APPLICATION NO.	FILING DATE	FIRST NAMED INVENTOR	ATTORNEY DOCKET NO.	CONFIRMATION NO.
10/779,959	02/17/2004	Ralph Lance Carter	03142-P0067A	9116
24126	7590	01/11/2005	EXAMINER	
ST. ONGE STEWARD JOHNSTON & REENS, LLC 986 BEDFORD STREET STAMFORD, CT 06905-5619			LYONS, MICHAEL A	
			ART UNIT	PAPER NUMBER
			2877

Office Action Summary	Application No. 10/779,959	Applicant(s) CARTER ET AL.	
	Examiner Michael A. Lyons	Art Unit 2877

DETAILED ACTION

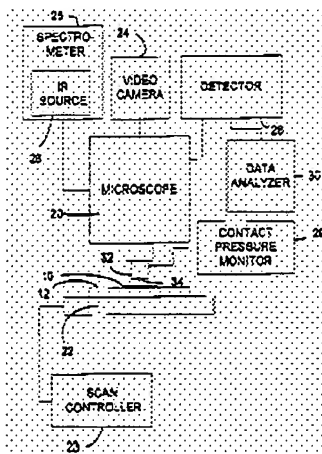
Claims 1-4 and 5-8 are rejected under 35 U.S.C. 102(b) as being clearly anticipated by Dukor (5,945,674).

Regarding claims 1-2 and 5-6, Dukor (Fig. 2) discloses a system and corresponding method for operating a FT-IR microscope 20 with a scanning spectrometer 25 that features an object stage 22 that is coupled to a scan controller 23 that moves the stage in conjunction with the scan of the spectrometer; Dukor discloses that "after the ATR infrared measurement is performed on one detection site in the sample, the object stage 22 is moved under the control of the scan controller so that the next detection site is positioned for ATR infrared measurement".

As for claims 3 and 7, nothing in Dukor discloses that the spectrometer is turned off while the stage is being moved.

As for claims 4 and 8, Dukor discloses detector 28.

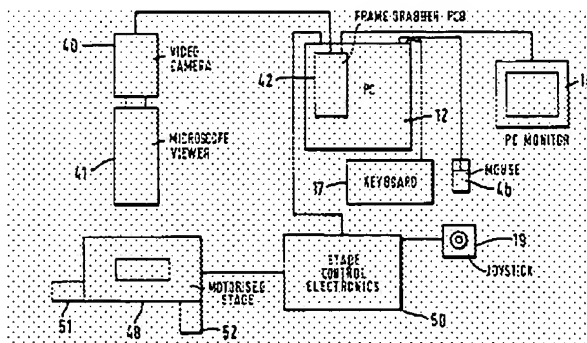
Claims 9-10 are rejected under 35 U.S.C. 103(a) as being unpatentable over Dukor (5,945,674) in view of Carter (6,006,140).

As for claim 9, Dukor discloses a data analyzer 30 for producing signals from the detector and a scan controller for controlling the microscope stage.

Dukor, however, fails to disclose an explicit scan controller for controlling the spectrometer, and a master controller for controlling the device as a whole.

Carter (Fig. 3) discloses the use of a PC 12 as a master controller for controlling the stage control 50 and video camera 40 of an infrared microscope stage control device. And, although no controller is disclosed for control of the spectrometer itself, Official Notice is taken as to the well known use of a controller for a spectrometer, since a controller would be inherent to the spectrometer to facilitate proper function.

Therefore, it would have been obvious to one of ordinary skill in the art at the time the invention was made to add an explicit controller to the spectrometer, and an additional computer as a master controller for the device as a whole in order to facilitate more precise, centralized control of the operation of the entire combined apparatus and method.

As for claim 10, the central controller would inherently facilitate the passage of signals from one controller of the device to another.
